PROJECT NO.: 42220144
RANGE ROAD REPAVING PHASE 1
 UNION TOWNSHIP
 LEBANON COUNTY, PENNSYLVANIA

SITE PLAN

Date: April 4, 2023
Solicitation/Bid Number: 6100058267
Opening Date/Time: April 21, 2023
Addendum Number: 2

DRAWN BY	DATE	DRAWING NO.
D. STERNER	15 MAR 2023	C.1.0
CHECKED BY	SCALE	
K. LLOYD	1" = 40'

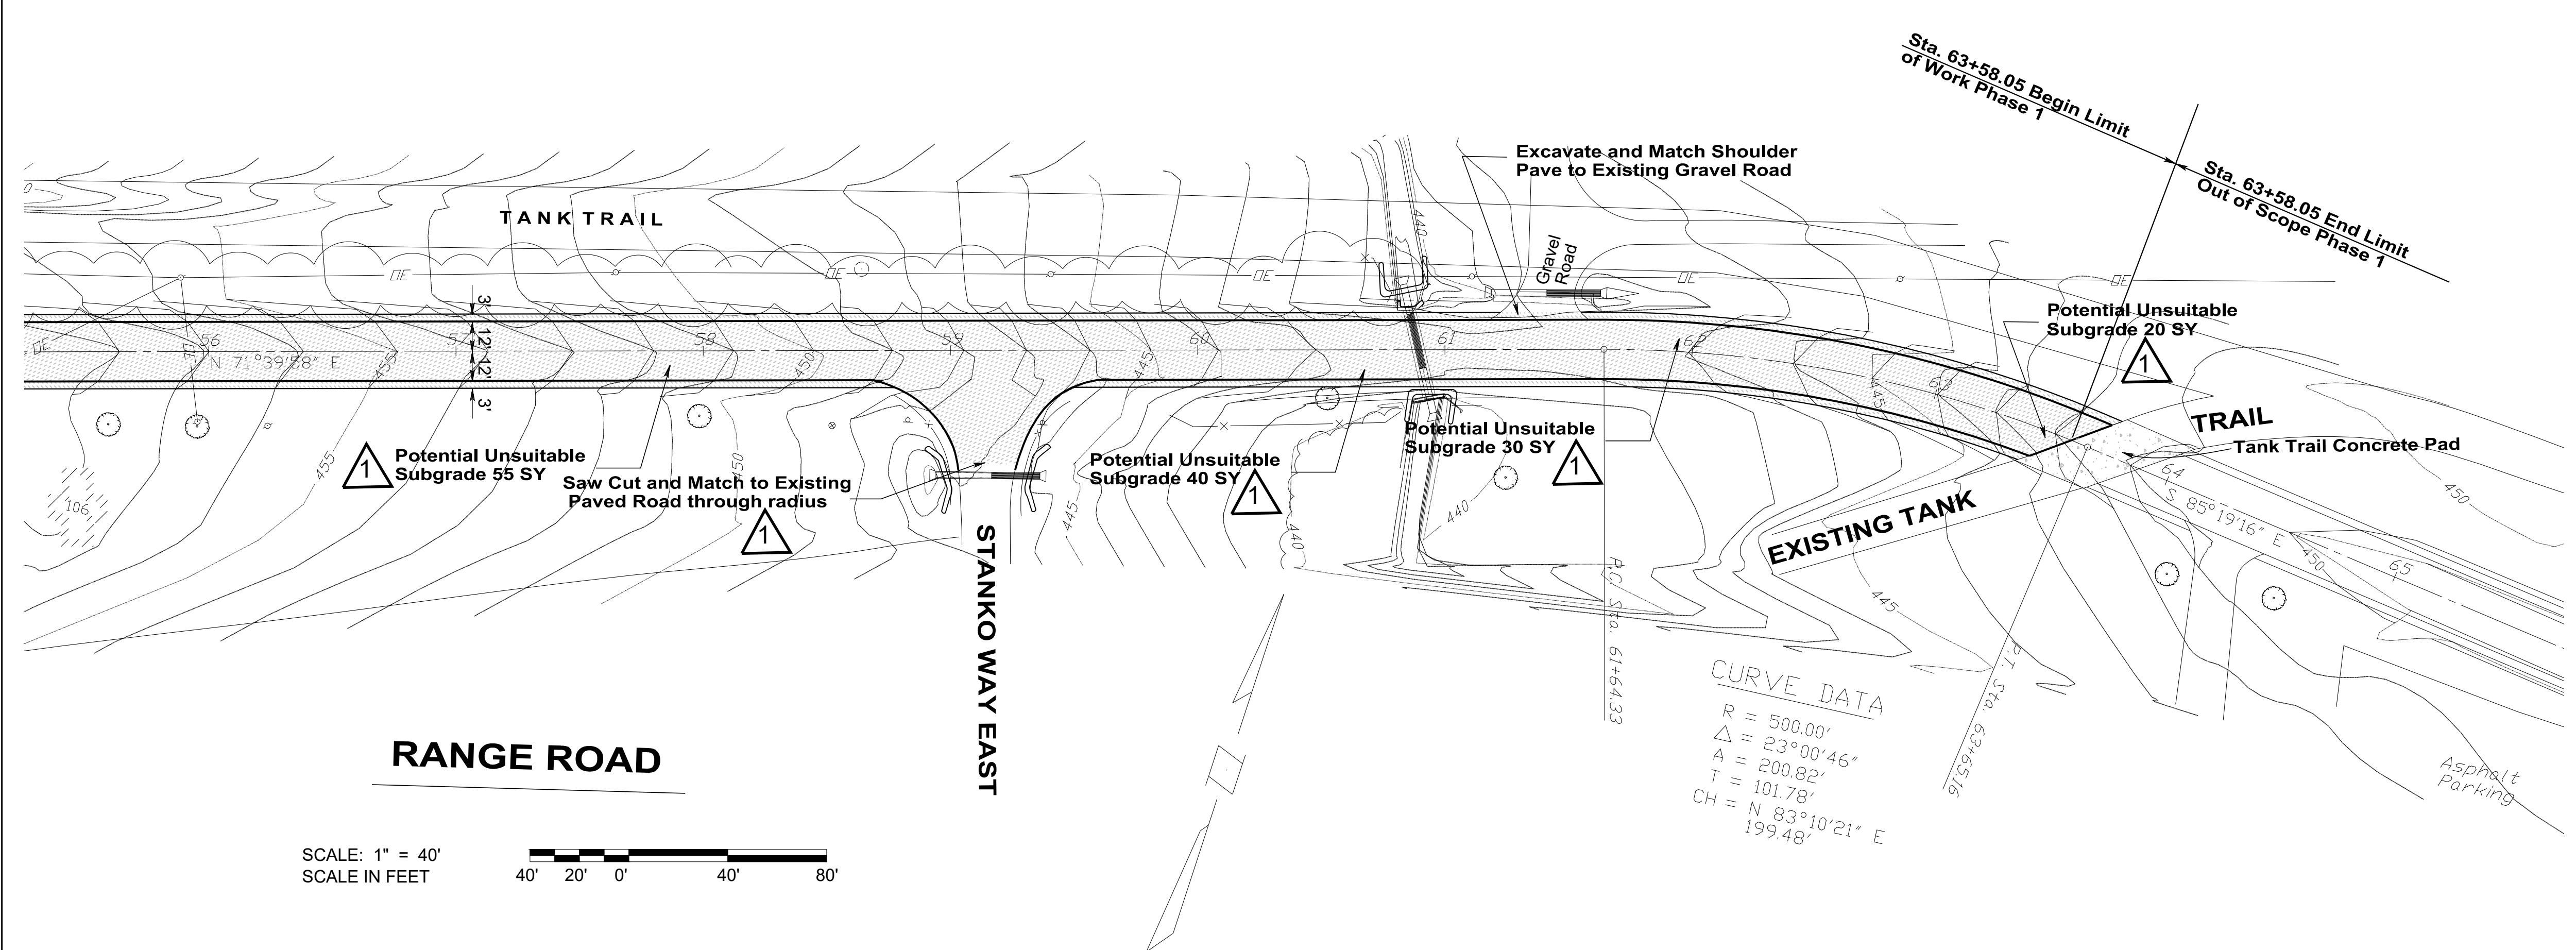
*Revised Site Plan, Sheet C.1.0 Rev 1 dated 4/4/2023
Updated Bid Proposal to add price per square yard*

NO.	DESCRIPTION	DATE
1	Revised per bid RFI	4/4/23
